STAFF RECOMMENDATION 1825 Fourth Avenue North September 21, 2016

Application: New construction—addition
District: Salemtown Neighborhood Conservation Zoning Overlay
Council District: 19
Map and Parcel Number: 08108029400
Applicant: Kyle Keaffaber & Prithvi Gummi
Project Lead: Melissa Baldock, melissa.baldock@nashville.gov

Description of Project: Application is to demolish an existing rear porch and construct a rear addition. The one-and-a-half story rear addition will approximately double the footprint of the historic house.

SITE PLAN

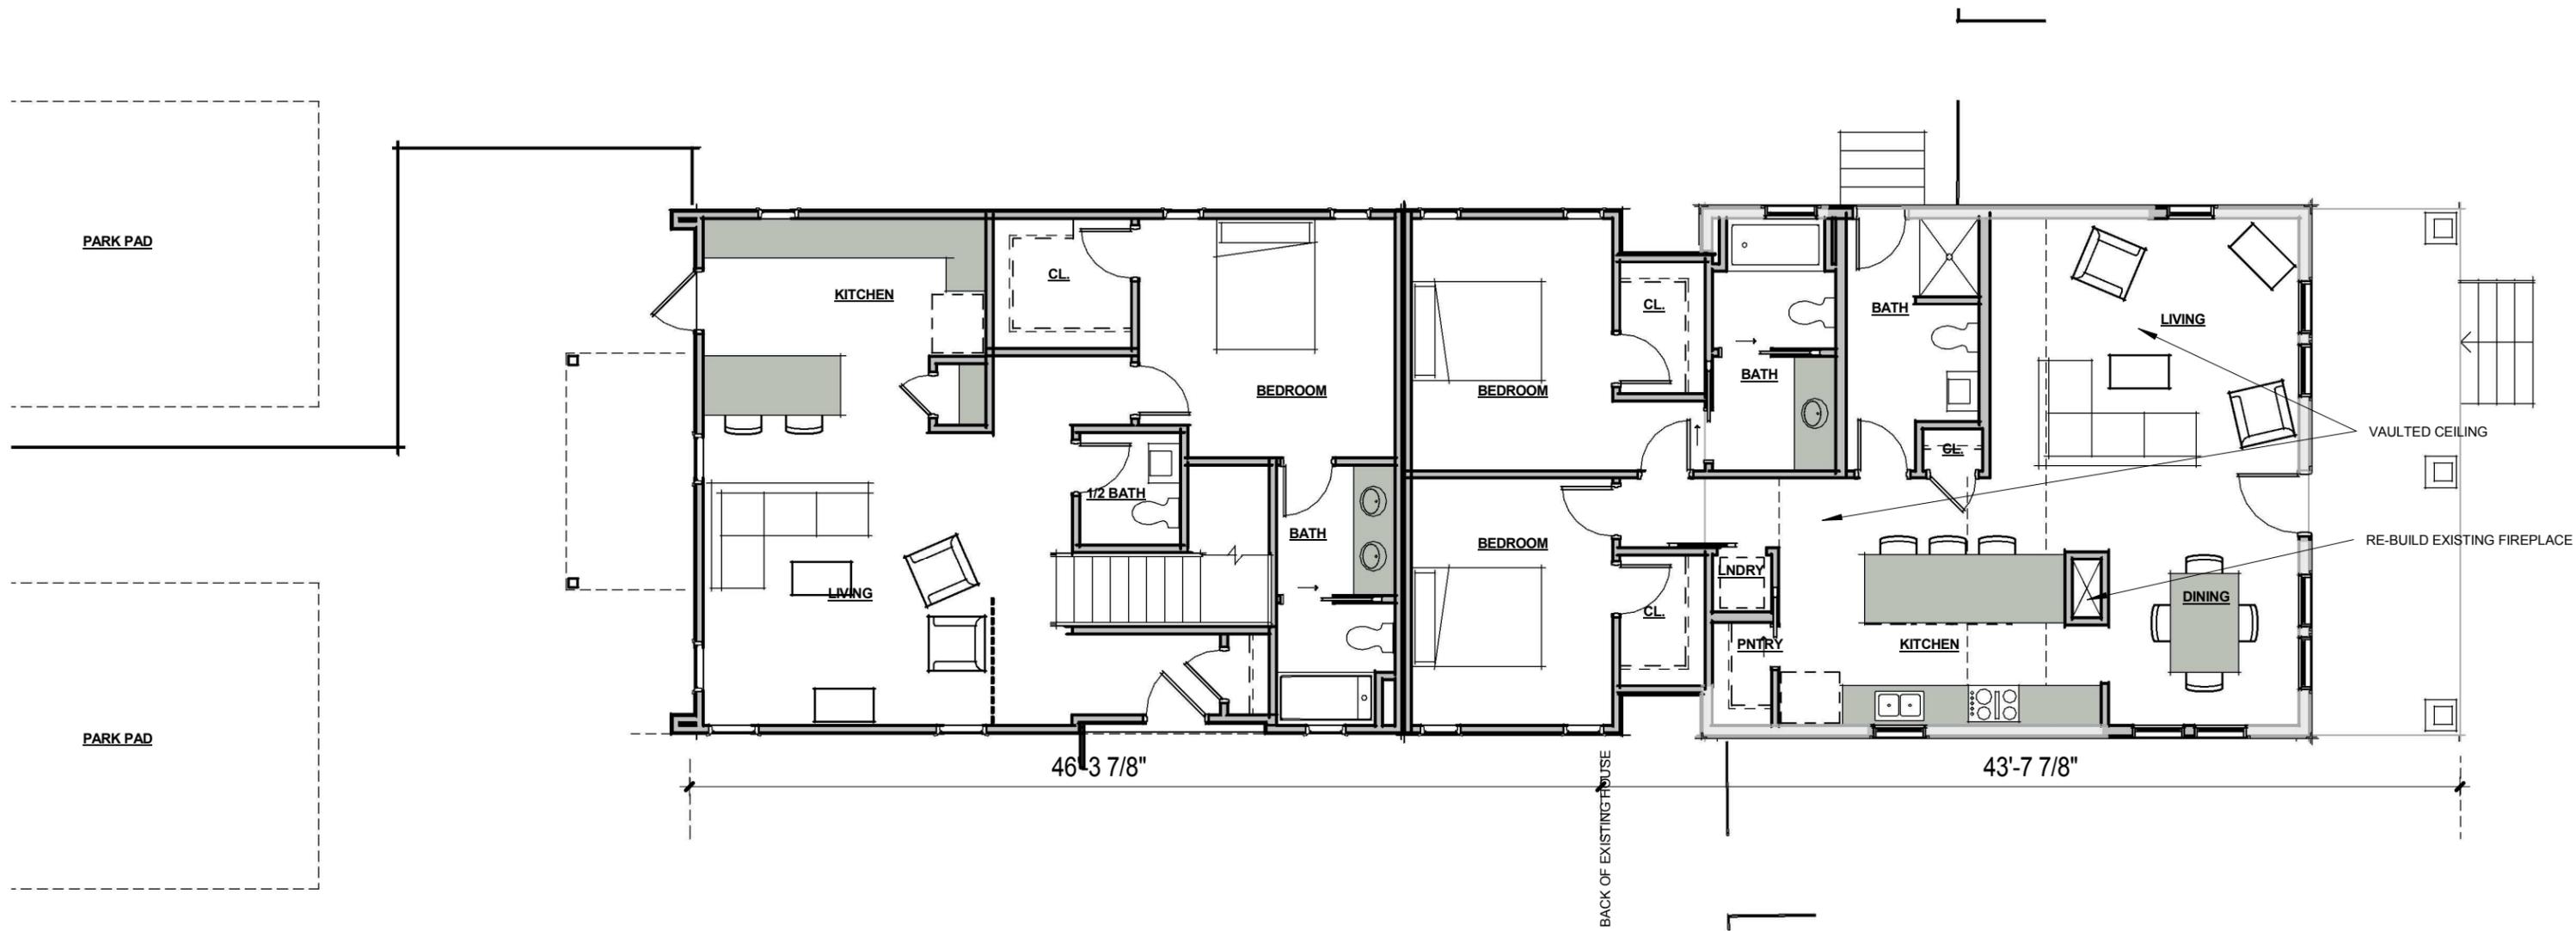
Location & Removability: The addition is located entirely behind the historic house, and is appropriately inset. The addition's roof will connect to the back slope of the historic roof about one foot, six inches (1'6") below the ridge, preserving a significant portion of the existing roof. This lower roof connector and the insets ensure that if the addition were to be removed in the future, the primary form and character of the historic house could still be discerned. Staff therefore finds that the project meets Sections IV.A. and IV.F. of the design guidelines.

Setback & Rhythm of Spacing: The addition meets all base zoning setbacks, and it will be no wider than the existing historic house. Staff therefore finds that the addition meets Sections III.C. and IV.G. of the design guidelines.

Appurtenances & Utilities: The applicant intends to install a wood fence on the property, which is appropriate. The location of the HVAC and other utilities was not noted. Staff recommends that the HVAC be located behind the house or on either side, beyond the mid-point of the house.

4. Staff approve the final details, dimensions and materials of all windows and doors prior to purchase and installation;
5. The HVAC be located behind the house or on either side, beyond the mid-point of the house; and
6. Staff approve the metal roof color, dimensions and texture.

NORTH ELEVATION - PRES

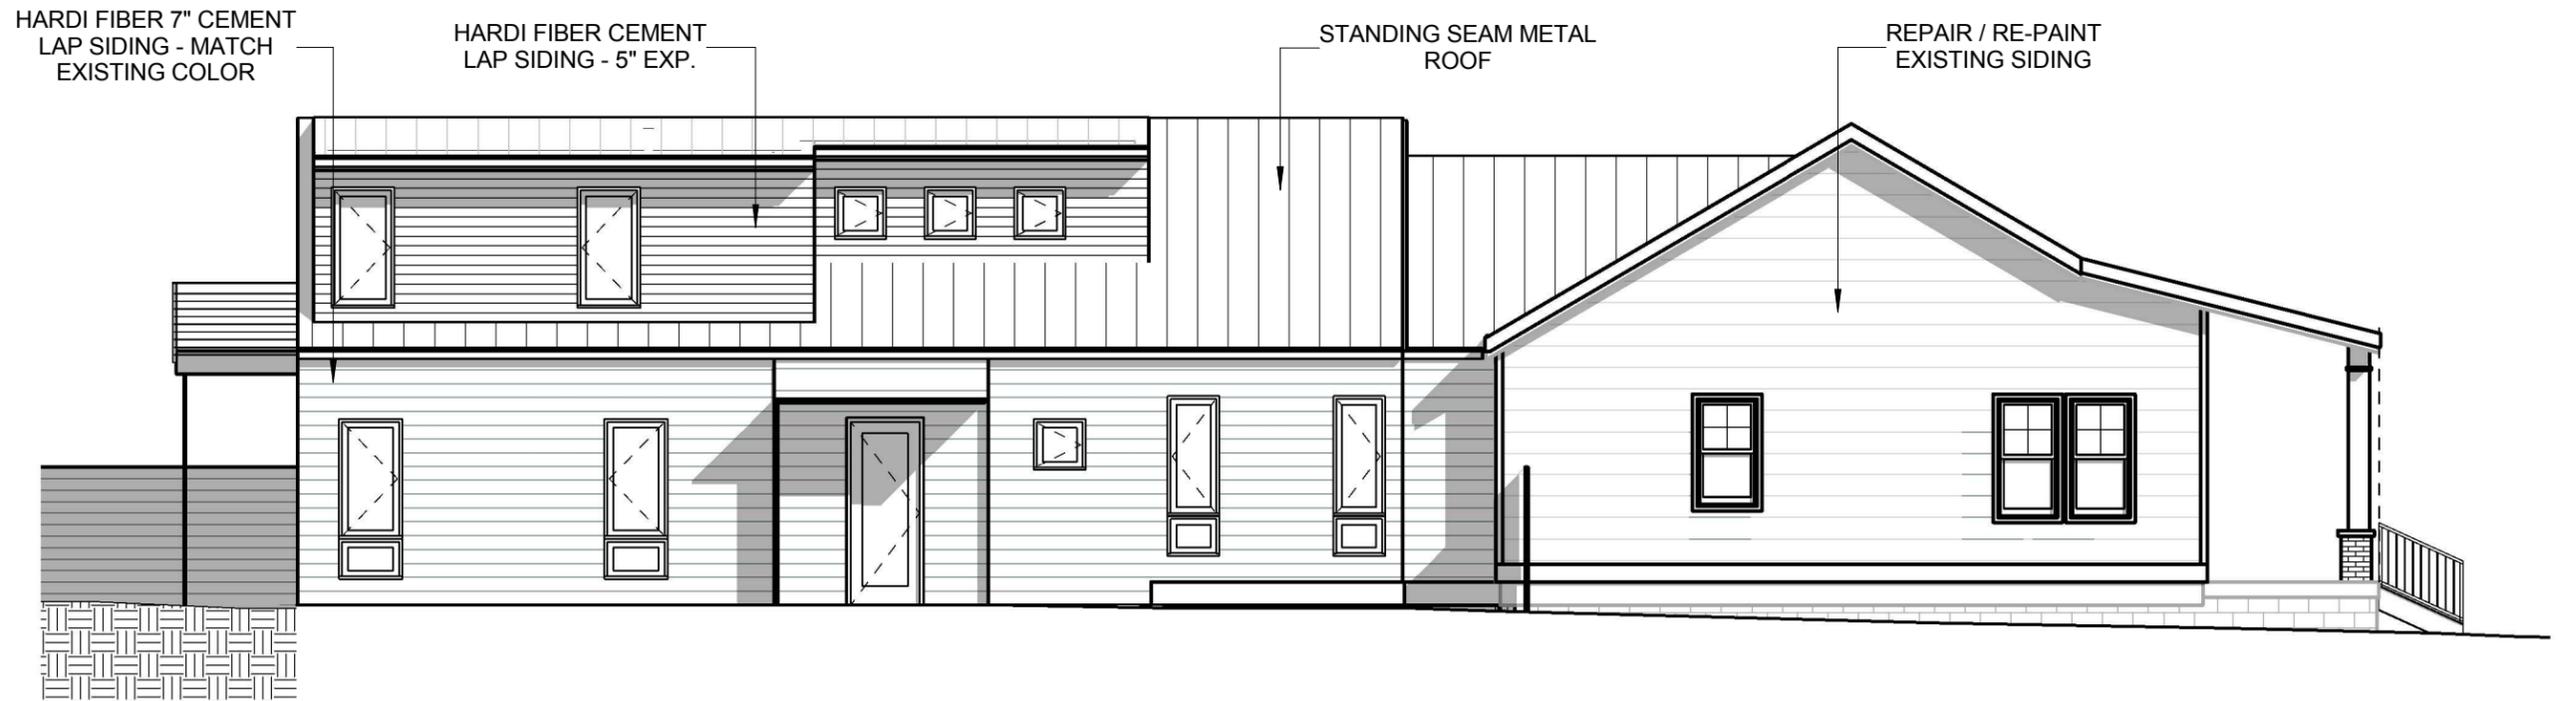
Height & Scale: The historic house is one story, and the proposed addition will be one-and-a-half stories. Its eave and ridge heights will match those of the historic house. The addition is inset two feet (2') for a depth of four feet (4') on both sides, preserving the back corners of the historic house. The addition will approximately double the footprint of the historic house. The existing house has a footprint of one thousand, one hundred, and seventy-nine square feet (1,179 sq. ft.), which includes the front and rear porches. After the construction of the addition, the house will have a footprint of two thousand, two hundred, and twenty-four square feet (2,224 sq.ft.). Staff finds that the proposed addition's height and scale are appropriate and meet Sections III.B. and IV. B. of the design guidelines.

The existing house has non-historic wide siding. It is likely that the historic siding is located underneath this siding, as the existing siding extends beyond the depth of the window trim (Figure 5). MHZC does not have the ability to require the applicant to remove the non-historic siding and reveal what is underneath. However, MHZC does regulate the materials on the new addition. The applicant is proposing to match the wide reveal of the non-historic siding. Staff does not find this to be appropriate, as the existing siding is not historic. The siding on the addition should have a maximum reveal of five inches (5").

Staff notes that the drawings do not show corner boards. MHZC has consistently required four inch (4") (nominal) wood corner-boards at the face of each exposed corner.

Roof form: The existing house has a side gable form with a 7/12 pitch. The applicant is proposing a gable form for the addition, with a slope of approximately 9/12. The addition includes shed roof dormers, with slopes of 2/12. The dormers are inset two feet (2') from the walls below. Staff finds that the project's roof forms meet Sections III.E., IV.C., and IV.G. of the design guidelines.

Proportion and Rhythm of Openings: The alteration to one window opening on the side façade is discussed under the "Partial Demolition" section. The primary windows on the addition will be twice as tall as they are wide. There is one expanse of eighteen feet (18') without a door or window opening on the right elevation. Staff finds this expanse to be appropriate because it is located towards the rear of the side façade and therefore will not be highly visible from the street. Staff finds that the addition's fenestration pattern meets Sections III.G. and IV. G. of the design guidelines.

1. Maximum reveal of the siding be five inches (5");
2. All exposed corners have nominal four inch (4") corner boards;
3. Staff approve a brick sample for the front porch columns;

EAST ELEVATION - PRES

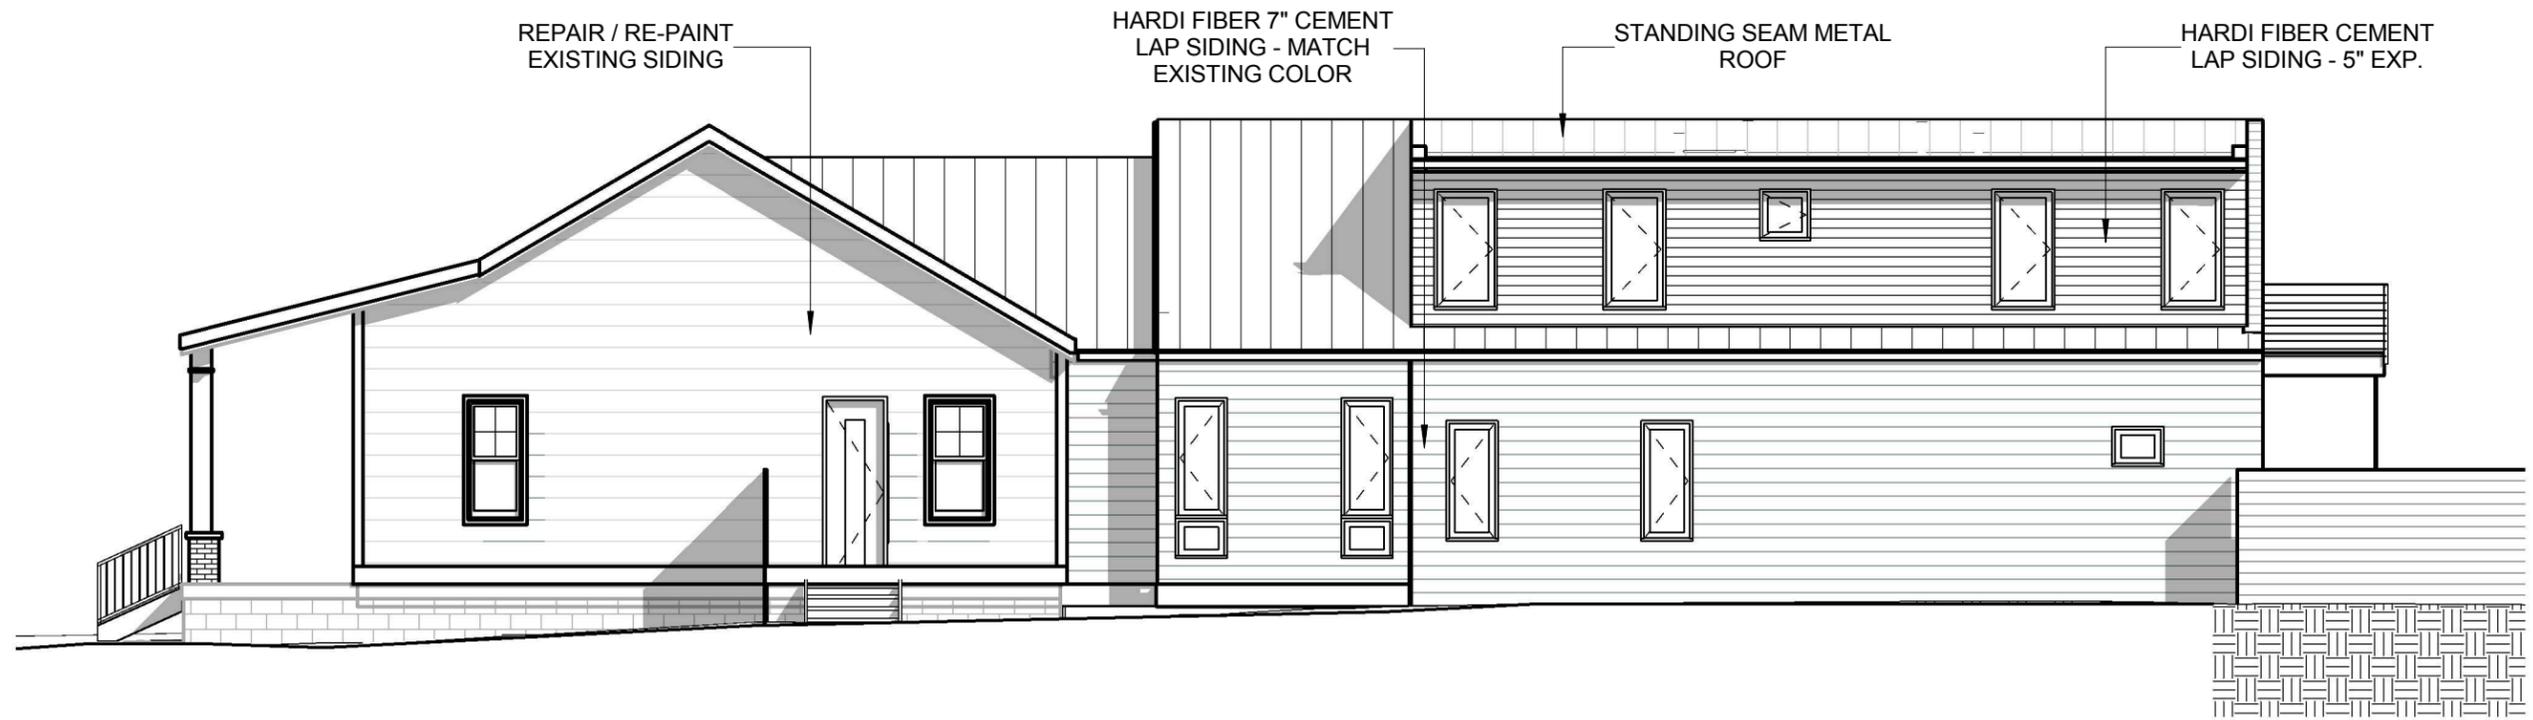
The applicant is also proposing to install a new door on the right façade, which is considered partial demolition (Figure 4). The door will be installed beyond the midpoint of the side façade, in the approximate location of an existing window. The door is necessary in order to provide a second means of egress for the front unit of this duplex. Because it is located beyond the midpoint, on a side façade, it will be less visible from the street. Staff finds it to be appropriate because of its location and because a second means of egress is required by fire code. Staff finds that the project meets Section IV.B.2. for appropriate partial demolition and does not meet Section IV.B.1. for inappropriate demolition.

Orientation: The new addition will create a duplex out of what is currently a single family house. The addition will not alter the house's primary orientation towards Fourth Avenue North. The primary entry on the front façade will remain unchanged. The entry to the rear, second duplex unit, will be on the left façade, recessed approximately a foot (1') from the main wall of the addition. The new entry is designed so that it reads as a secondary, side entrance, which is appropriate. Another side entry will be added on the right side façade of the historic house in order to meet fire code requirements. This side entry will not affect the house's orientation towards Fourth Avenue North and will also read like a secondary, side entry. Vehicular access to the site will be via the alley. Parking for the site will be accommodated through uncovered parking pads at the rear. The existing central sidewalk leading to the front porch will remain, and the applicant intends to install new walkways leading to the side entries on both sides of the property. Staff finds that the project meets Sections III.F. and IV.G. of the design guidelines.
